Attachment B

Selected Drawings

New The Salvation Army Accommodation & Mixed Use Development

PROJECT
Foster House
5-19 Mary St, Surry Hills NSW 2010

DRAWING TITLE			
Section B - East West 5-15			
JOB NO	DRAWN	SCALE	DRAWING NO.
22.19	AR/JK	1:200	2.302
DATE	CHECKED	PLOT DATE	REVISION
23/5/22	PT		D

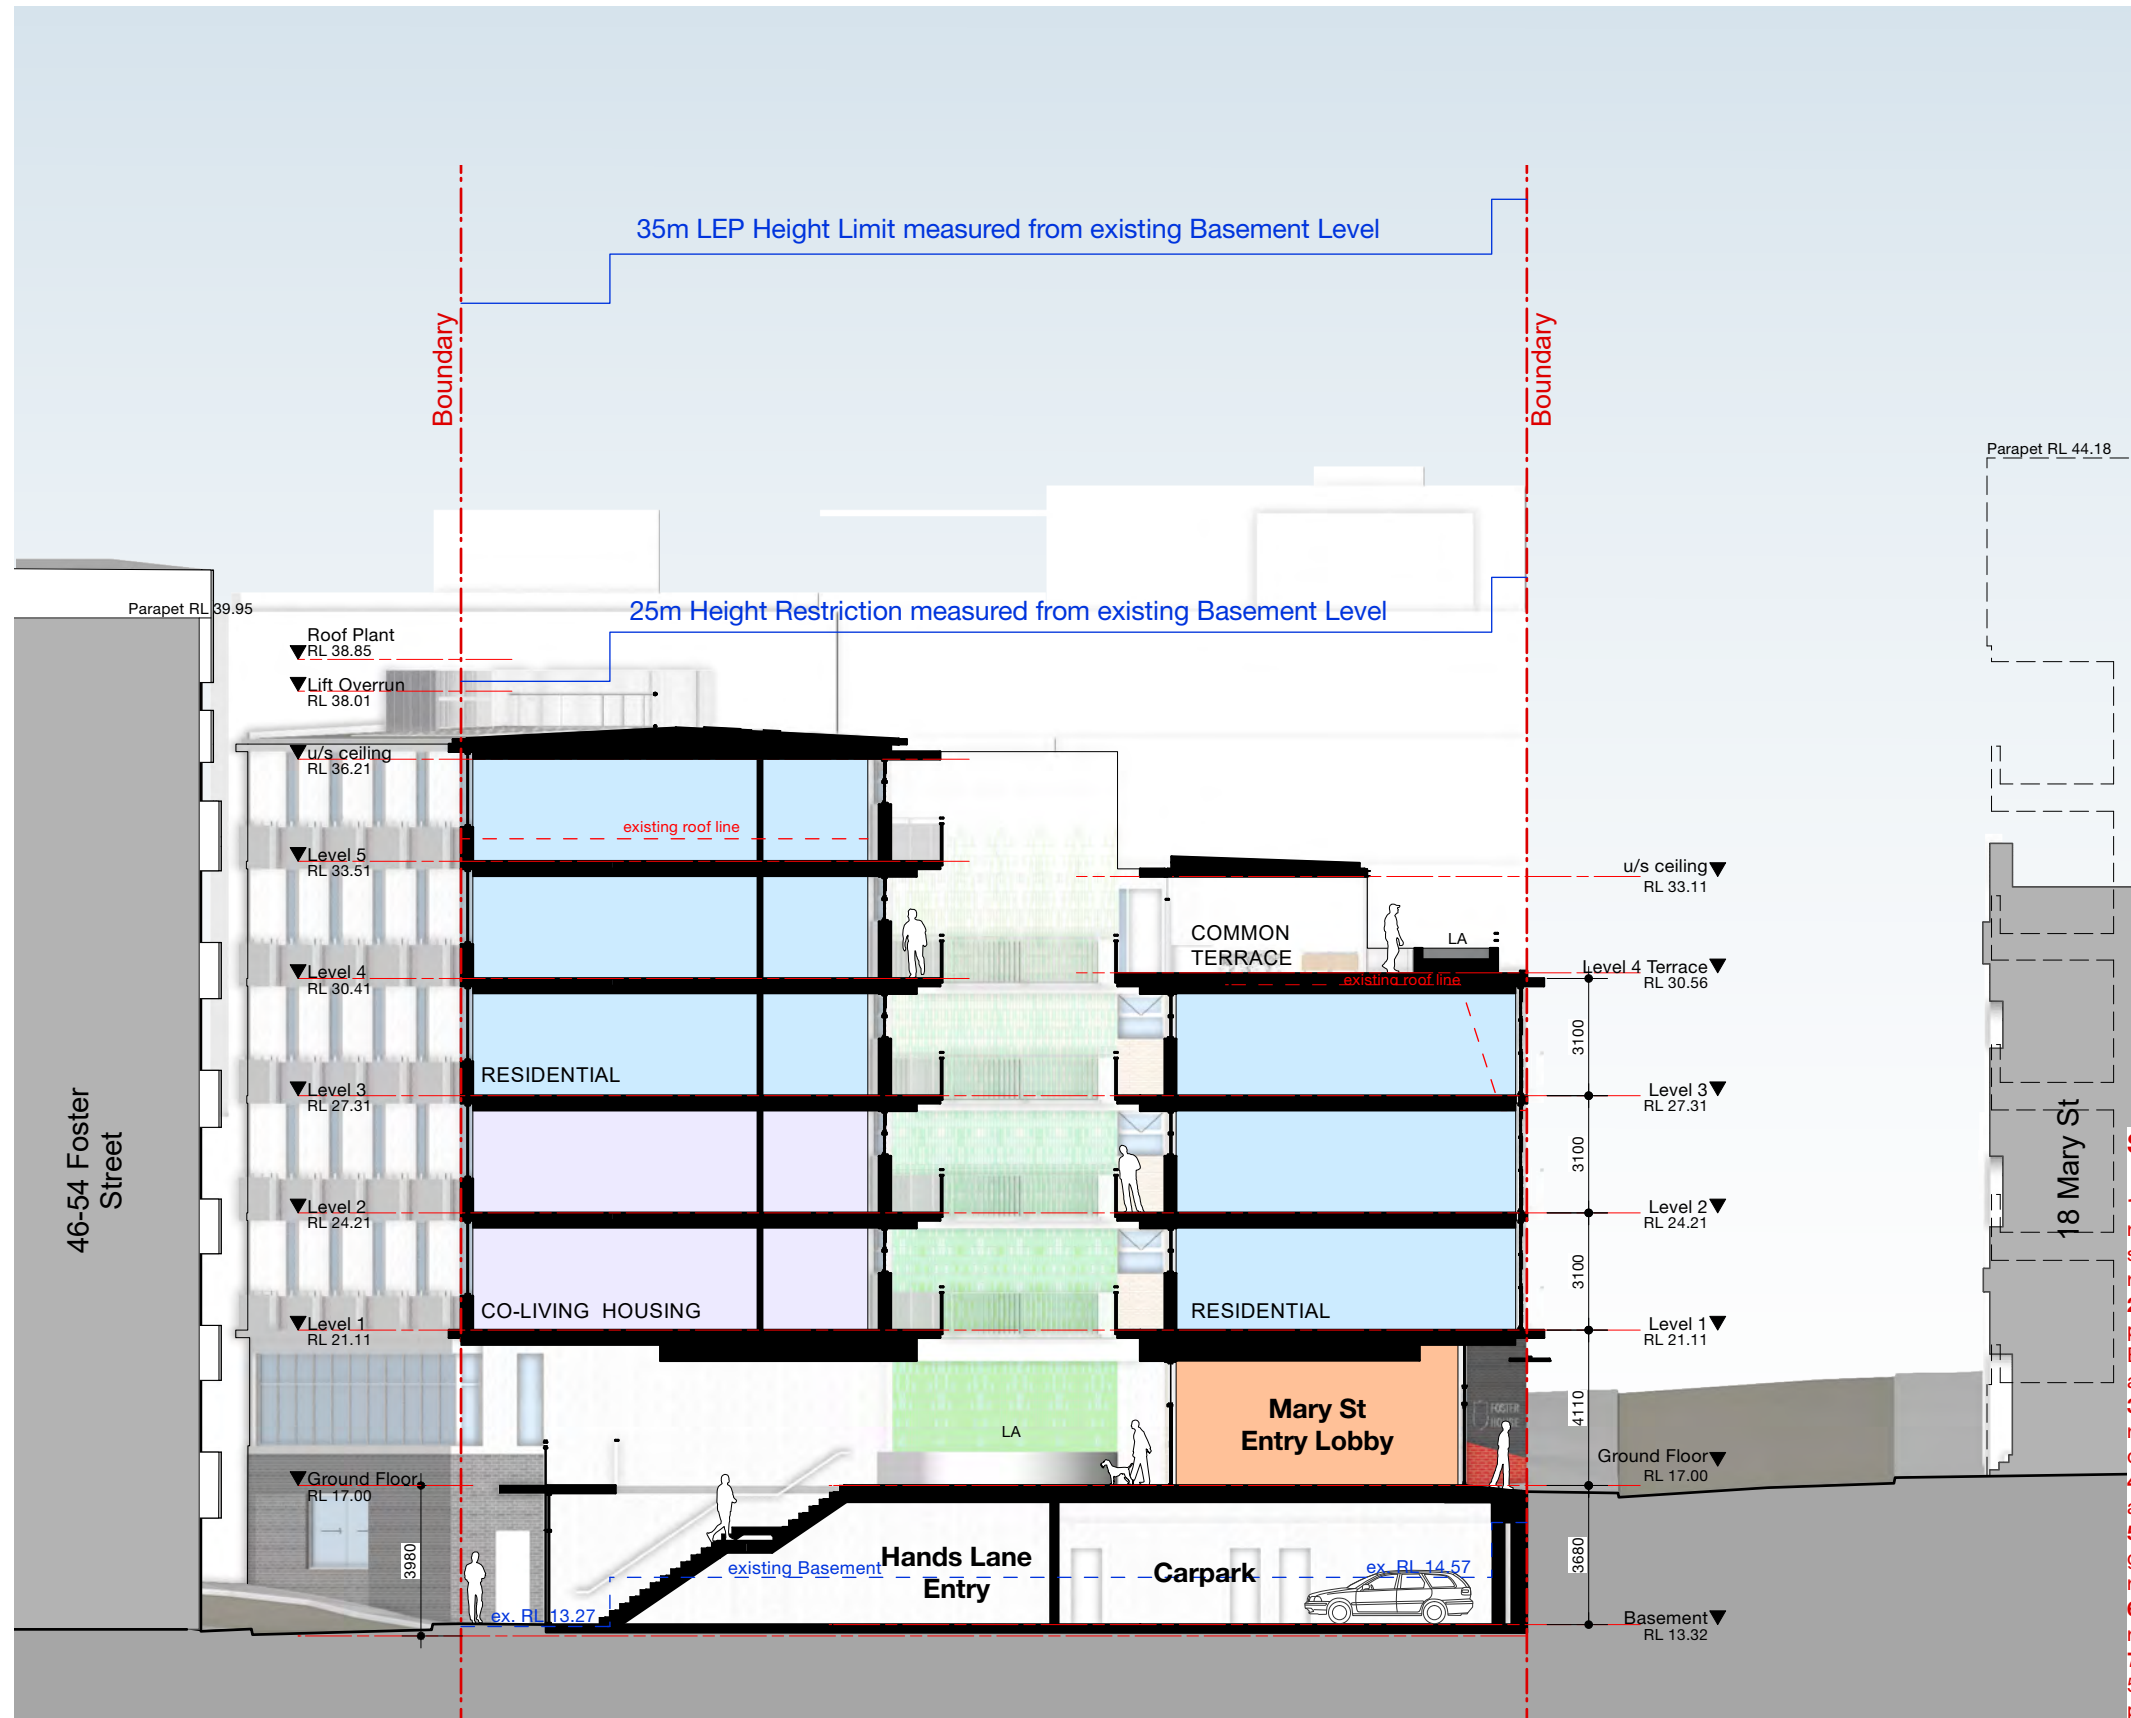
1. Provide new substation per Ausgrid instruction, remove existing. New substation positioned to the south of 5-15, with driveway, pump room, waste rooms and end-of-trip repositioned accordingly

2. OSD removed from 5-15, water quality chamber provided to civil stormwater engineers detail. Balcony & stay-over unit above adjusted to accommodate access hatch as required.

3. Provide RL's at egress and entry points as requested, provide ledge at 5-15 entry to reduce downslope to door.
4. FHB for 17-19 repositioned to Mary St entry to achieve clearance from proposed substation

7. Remove 450mm projections to Hands Lane in 5-15 for units south of the lift core, adjusting unit plan accordingly
8. Remove 450mm projection to Hands Lane in 17-19, adjusting plans accordingly

9. Remove projection to Mary St for balcony of unit 112, adjust unit plan accordingly

DRAWING TITLE			
Section C - North South (Courtyard)			
JOB NO	DRAWN	SCALE	DRAWING NO.
22.19	AR/JK	1:200	2.303
DATE	CHECKED	PLOT DATE	REVISION
23/5/22	PT		D

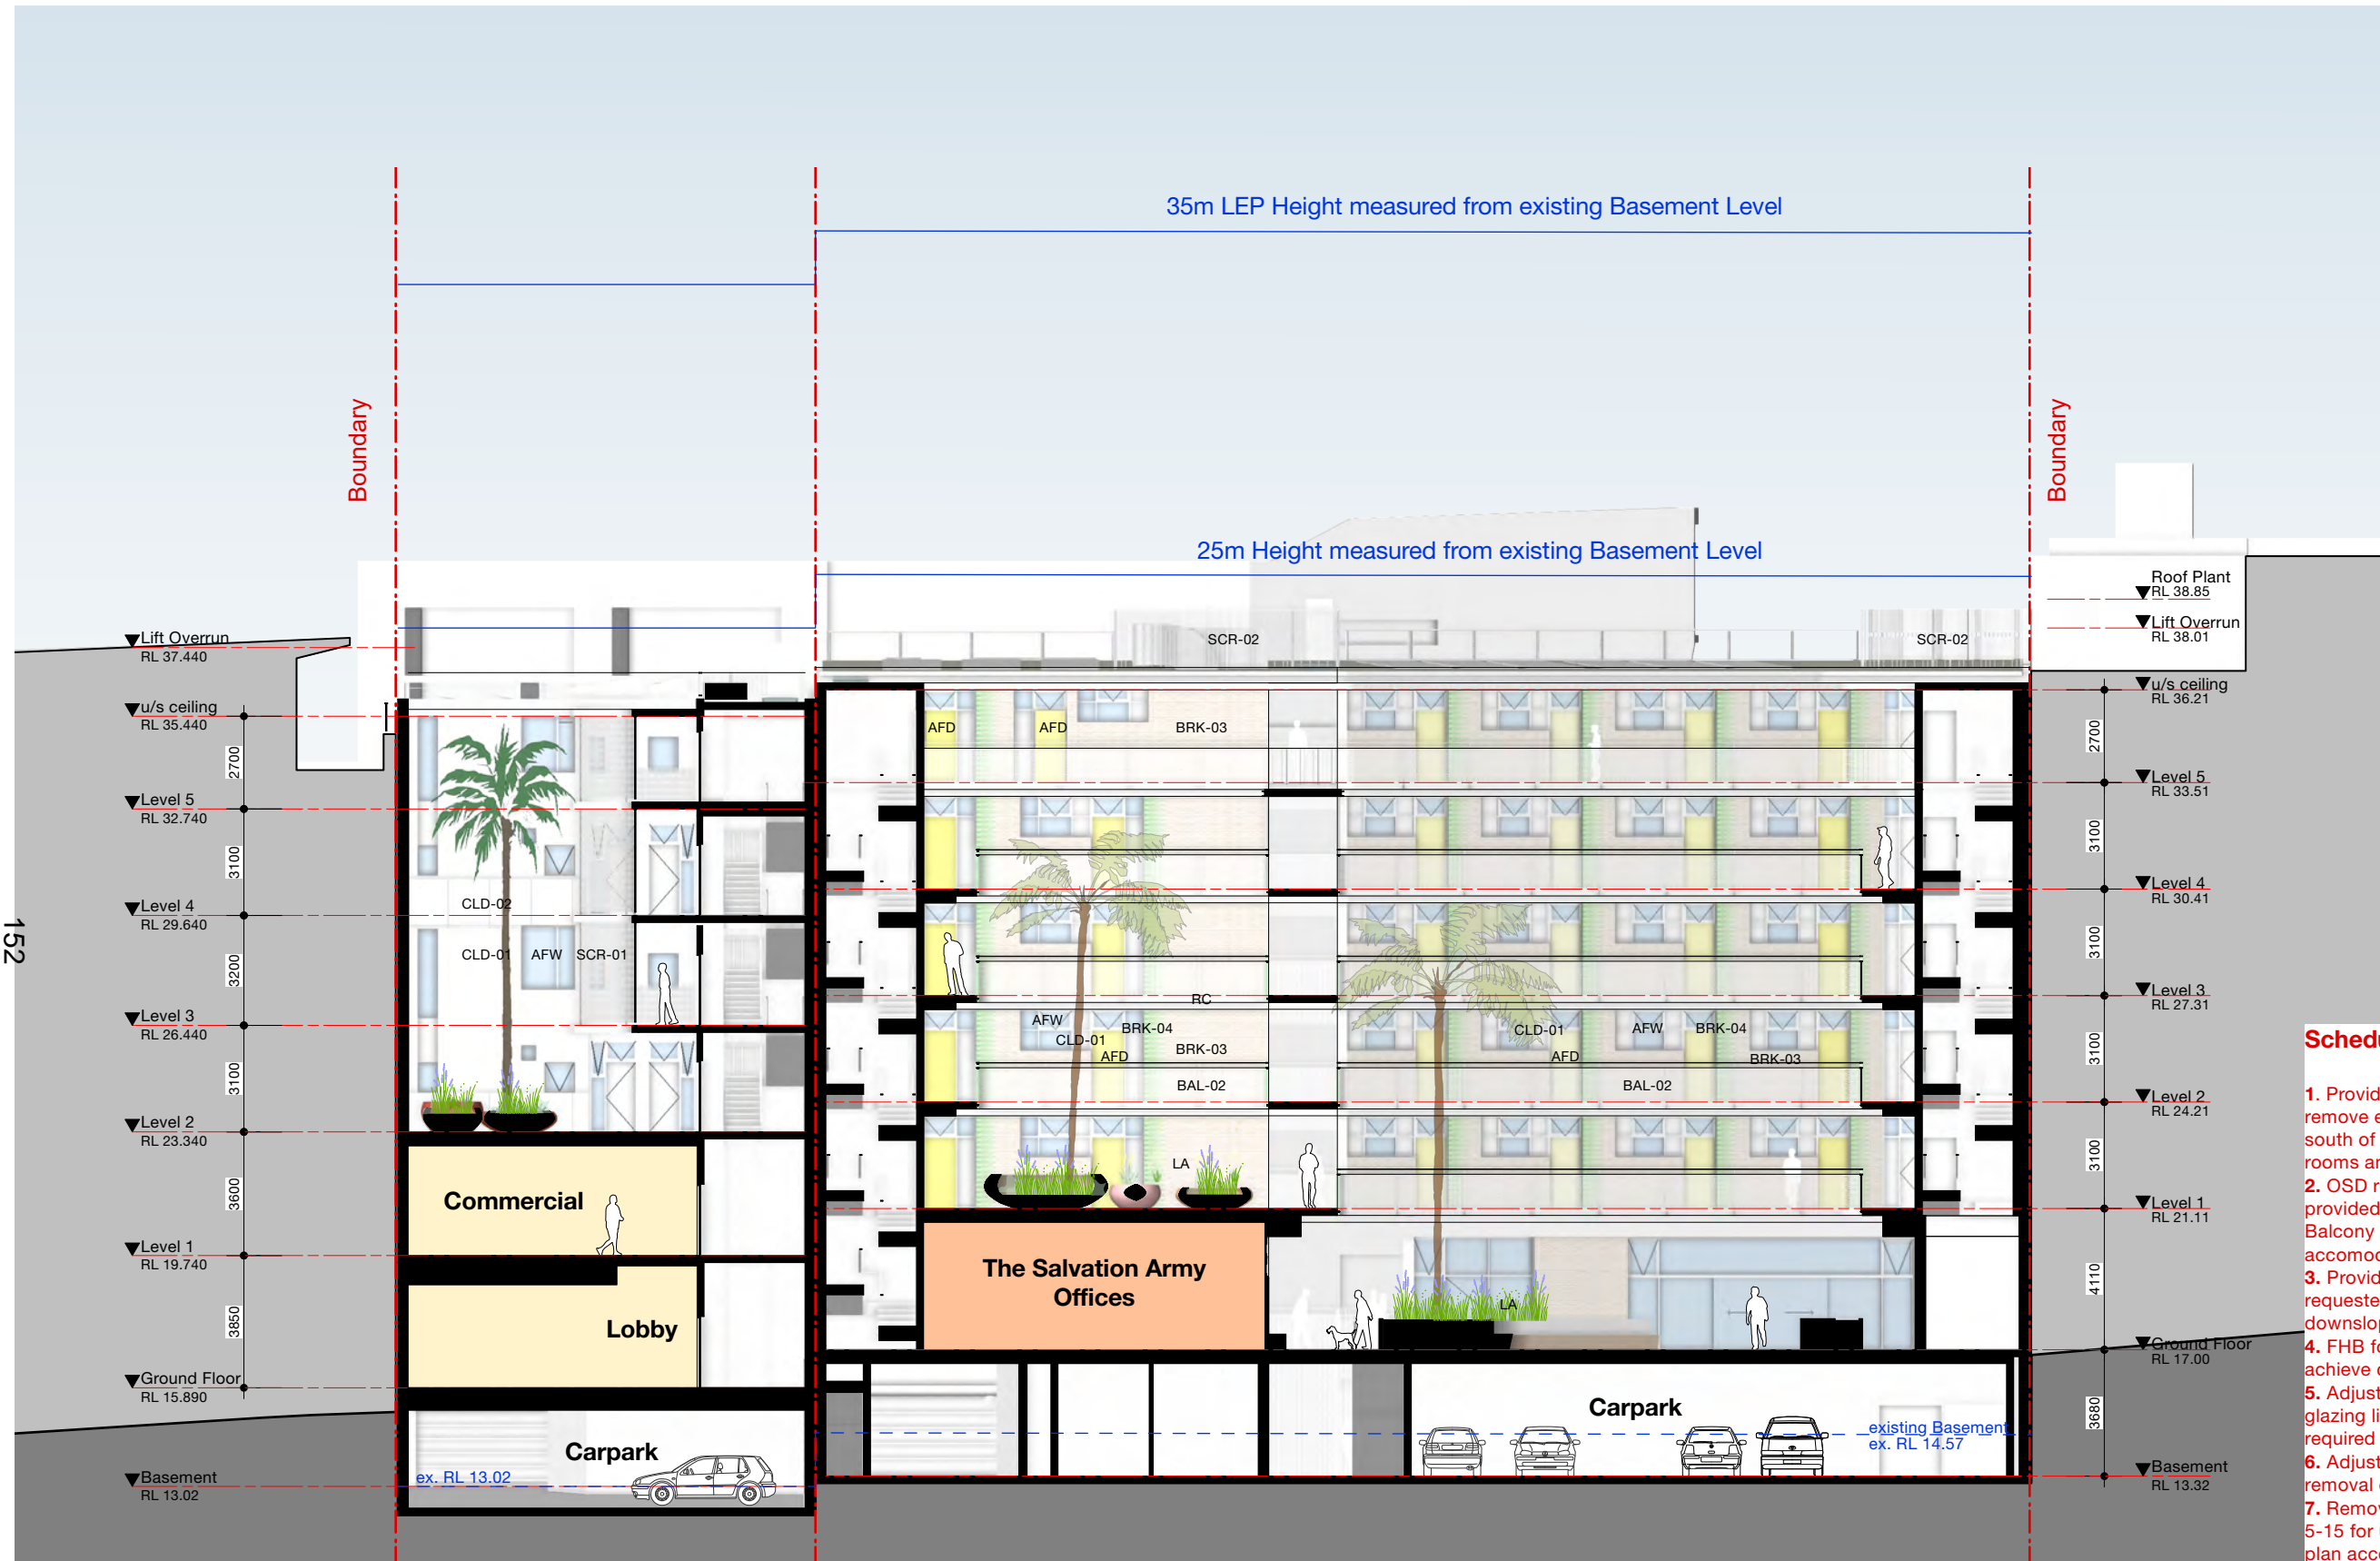
1. Provide new substation per Ausgrid instruction, remove existing. New substation positioned to the south of 5-15, with driveway, pump room, waste rooms and end-of-trip repositioned accordingly

2. OSD removed from 5-15, water quality chamber provided to civil stormwater engineers detail. Balcony & stay-over unit above adjusted to accommodate access hatch as required.

3. Provide RL's at egress and entry points as requested, provide ledge at 5-15 entry to reduce downslope to door.
4. FHB for 17-19 repositioned to Mary St entry to achieve clearance from proposed substation

7. Remove 450mm projections to Hands Lane in 5-15 for units south of the lift core, adjusting unit plan accordingly
8. Remove 450mm projection to Hands Lane in 17-19, adjusting plans accordingly

9. Remove projection to Mary St for balcony of unit 112, adjust unit plan accordingly
